Access Compliance Report

Public Rights-of-Way

(Curb Ramps)

Intersection ID: 32117	Main Street: DUNDALK_RD	Cross Street: NEWRY_CT	Location: S
ADA ID: C744DE0DFBA4	Ramp Type: BlendTrans1	Initial Pass/Fail: Fail	Overall Compliance: No
Severity Score: 10			
Codes/Mitigation Info/Possible Solution		Field Measurements/Component Compliance

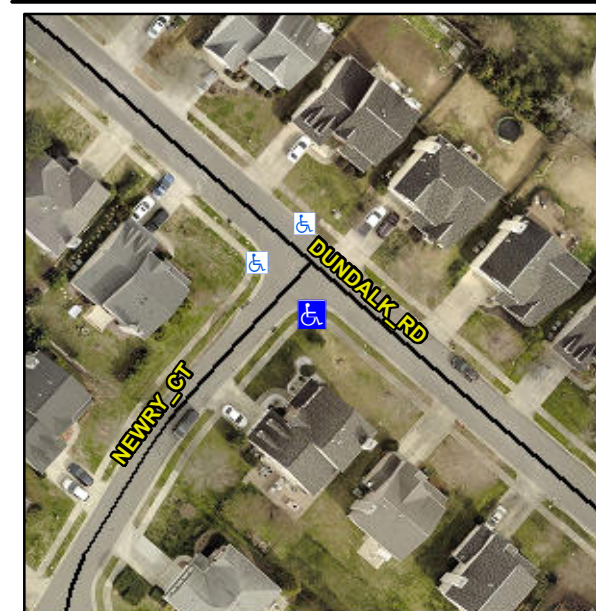
Not Found, R304.5.1, R304.5.3

Compliance	Description	Data	Compliance	Description	Data
N/A	Ramp Length (in)	49.5	Yes	BlendTrans Slope (%)	4.2
No	Ramp Width (in)	38.0	No	BlendTrans XSlope (%)	4.1
N/A	Flare Type LT	N/A	N/A	Flare Type RT	N/A
N/A	Flare Slope LT (%)	N/A	N/A	Flare Slope RT (%)	N/A
N/A	Flare Traversable LT?	N/A	N/A	Flare Traversable RT?	N/A
N/A	Landing Length (in)	N/A	N/A	DWS Provided?	N/A
N/A	Landing Width (in)	N/A	N/A	DWS Contrast?	N/A
N/A	Landing Slope (%)	N/A	N/A	DWS Length (in)	N/A
N/A	Landing X Slope (%)	N/A	N/A	DWS Full Width?	N/A
N/A	Landing Curb? (Y/N)	N/A	N/A	DWS Offset (in)	N/A
N/A	Shared Landing?	N/A			
N/A	Gutter Ponding?	N/A	N/A	Gutter Slope (%)	N/A
N/A	Gutter Lip Ht (in)	N/A	N/A	Gutter X Slope (%)	N/A
N/A	Painted X Walk1?	No	N/A	Painted X Walk2?	No
	X Walk 1 Direction	To NE		X Walk 2 Direction	To NW
	X Walk 1 Width (in)	N/A		X Walk 2 Width (in)	N/A
	X Walk 1 Slope (%)	2.9		X Walk 2 Slope (%)	6.3
	X Walk 1 X Slope (%)	5.9		X Walk 2 X Slope (%)	3.9

N/A	Ramp inside XWalk1?	N/A	N/A	Ramp inside XWalk2?	N/A
	Road Slope (%)	2.4		Clear Space?	N/A
	Road X Slope (%)	7.5	N/A	Clear Space to XWalk (in)	N/A
N/A	Any Obstructions?	N/A	N/A	Storm Grate/Utility Hazard?	N/A
	Obstruction Type			Storm Grate/Utility Type	
		N/A			N/A
			Yes	Surface Condition? (G/P)	Good
			No	Curb Slope (%)	10.8

Remove & Replace Curb Ramp With Two New Directional Ramps or Equivalent.
